ADDENDUM #1

Project Name	SCC- Giles Campus Horticulture Pavilion Renovation
Project Number	H59-N385-PD
Date Issued	June 29, 2026

The following items below supersede the originally published bid documents and are intended to clarify the requirements for the Spartanburg Community College Giles Campus Horticulture Pavilion Renovation project.

ADDENDUM #1 MD-1

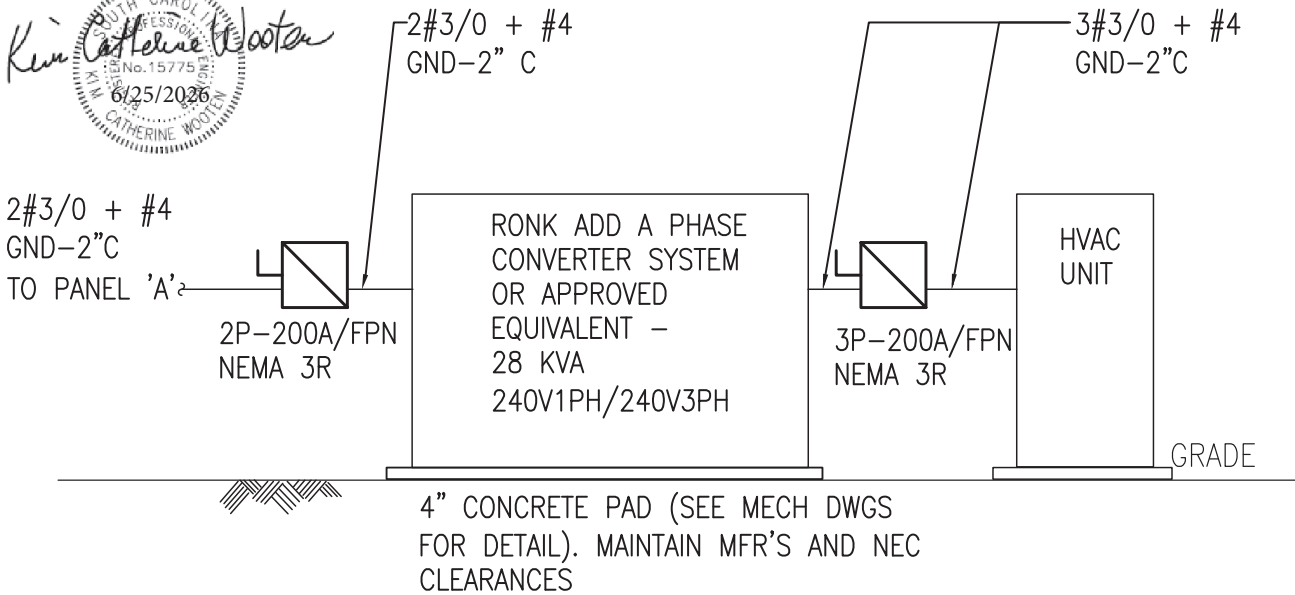
1. In Sheet M-0.02, the heat pump's 30 kW 3-phase electric auxiliary heater has been removed and the electrical values in the HVAC unit schedule has changed. Note 14 has been added to add 2x 15 kW single-phase 240V open coil duct heaters (30kW total), UL or ETL listed, Markel Mechanical HF, or approved equal. Heaters must meet the following specifications:

2. In Sheet M-0.02, the sequence of operations for the new 15 kW duct Auxiliary heaters have been added.

- 12.UNIT WILL BE GROUND PAD MOUNTED
- 13.PROVIDE SMOKE SENSOR IN RETURN DUCT
14. PROVIDE 2X 15 KW (30 KW TOTAL) 240V 1P DUCT HEATERS, MARKEL MECHANICAL HF, OR APPROVED EQUAL.

- HEATING SETPOINTS SHALL BE
 - OCCUPIED MODE: 70°F (ADJ.)
 - UNOCCUPIED MODE: 65°F (ADJ.)
- AUXILIARY HEAT
 - WHEN THE SPACE TEMPERATURE FALLS BELOW THE ACTIVE HEATING SETPOINT BY MORE THAN THE AUXILIARY HEAT OFFSET (3°F, ADJ.), ELECTRIC STAGES ARE COMMANDED ON, ALLOW FOR 3 STAGES.
 - WHEN THE HEAT PUMP HEATING IS LOCKED OUT, THE COMPRESSORS WILL NOT BE USED FOR HEATING AND THE INSTALLED AUXILIARY ELECTRIC HEATING STAGES WILL BE USED, FOLLOWING THE ABOVE SEQUENCE.

ADD A PHASE CONVERTER DETAIL

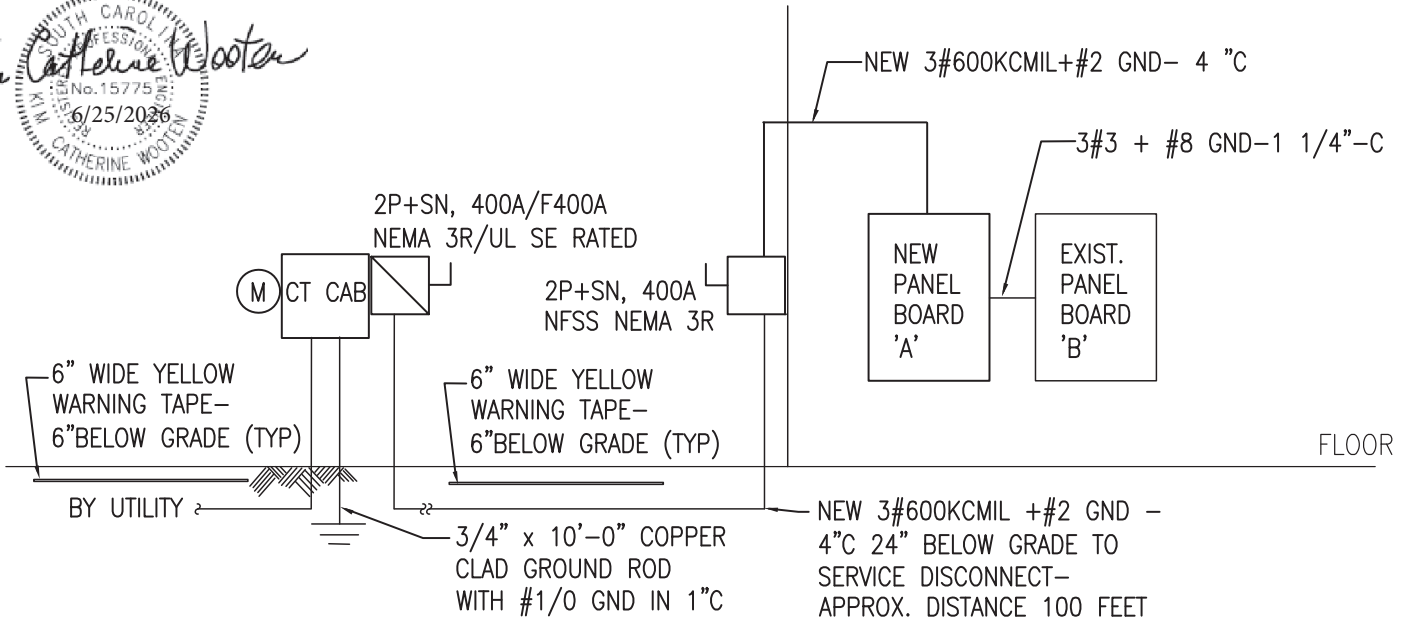
7. In Sheet E-1.2, Add A Phase Converter Detail, the phase converter system was clarified which altered the required conductors and disconnect to the converter. An additional note was added to clarify that the phase converter will now only be used for motors, not for the duct heaters since the new duct heaters are now 1-Phase.

- A. PROVIDE CONTROL AND POWER WIRING FROM PHASE CONVERTER TO HVAC UNIT CONTROLLER AND BETWEEN INTERNAL PHASE CONVERTER(S) PER MANUFACTURER'S INSTRUCTIONS.
- B. CONNECT PHASE CONVERTER(S) IN PARALLEL TO PROVIDE THREE PHASE POWER PER MANUFACTURER'S INSTRUCTIONS. PROVIDE INTERNAL WIRING AS DIRECTED BY MFR.
- C. HVAC UNIT SHALL NOT RUN UNTIL PHASE CONVERTER SENDS START SIGNAL TO HVAC UNIT AFTER THREE PHASE POWER IS AVAILABLE.
- D. RONK PHASE CONVERTER IS FOR MOTORS ONLY. DUCT HEATERS SHALL BE FED FROM SOURCE INDICATED ON THE ELECTRICAL DRAWINGS.

ED-4

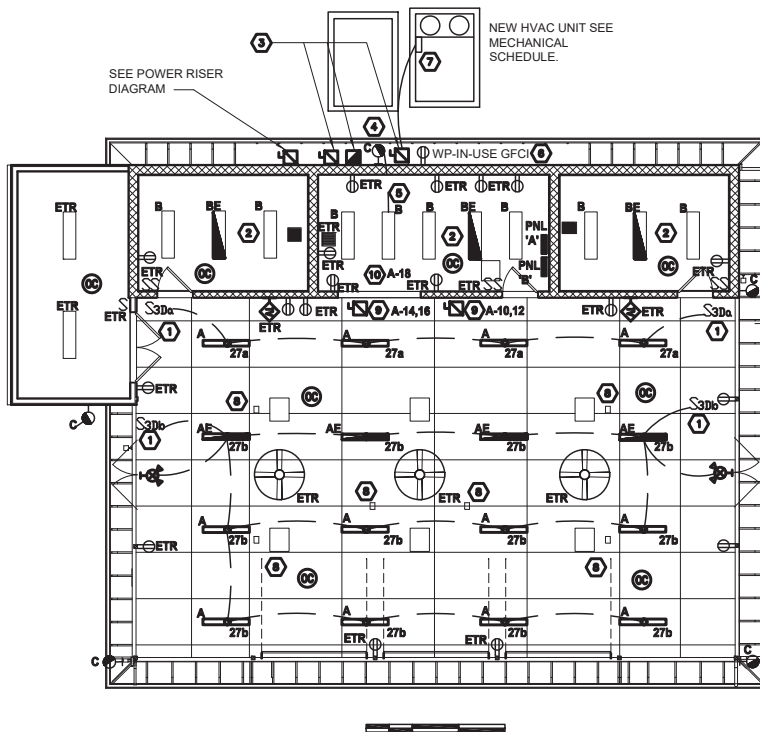
10. In Sheet E-1.2, Panelboard Schedule A was altered to reflect the removal of the 30 kW auxiliary heater from the HP and the addition of the two new 15 kW auxiliary duct heaters.

PANELBOARD "A"										LOCATION: WORK ROOM										400 A MAIN BUS RATING																	
VOLTAGE : 240 / 120V 1PH 3W										MOUNTING: SURFACE										400 A MAIN LUGS ONLY																	
BRANCH CIRCUIT										BRKR				BRKR		BRANCH CIRCUIT																					
CKT	LOAD DESCRIPTION	LOAD (KVA)						WIRE SIZE	C (IN)	TRIP/POLE	PHASE		TRIP/POLE	WIRE SIZE	C (IN)	LOAD (KVA)						LOAD DESCRIPTION	CKT														
		LTG	REC	MTR	H/C	OTH	KIT				A	B				LTG	REC	MTR	H/C	OTH	KIT																
1	ADD A PHASE CONVERTER FOR NEW HVAC UNIT NOTE D.			8.40				SEE POWER RISER DIAGRAM		200/2														UNUSABLE OPPOSITE SUB FEED BREAKER	2 4 6												
3				8.40																																	
5																																					
7									20/1			20/1						0.36						8													
9	EXISTING PANELBOARD 'B'	1.10	3.24	0.60	0.00	0.00	1.72	SEE POWER RISER DIAGRAM		100/2			90/2	2#3,1#8G	1"					15.00					ELEC. HEAT	10 12

11		0.55	2.88	1.00	0.00	0.00	0.00																	15.00													
13	SPARE								20/2			90/2	2#3,1#8G	1"					15.00					ELEC. HEAT	14 16												
15	-																		15.00																		
17	SPARE								20/2			20/1	2#12, #12G	3/4"	0.10									ATTIC LIGHT	18												
19	-											20/1											SPARE	20													
21	SPACE ONLY											20/1											SPARE	22													
23	SPACE ONLY											20/1											SPARE	24
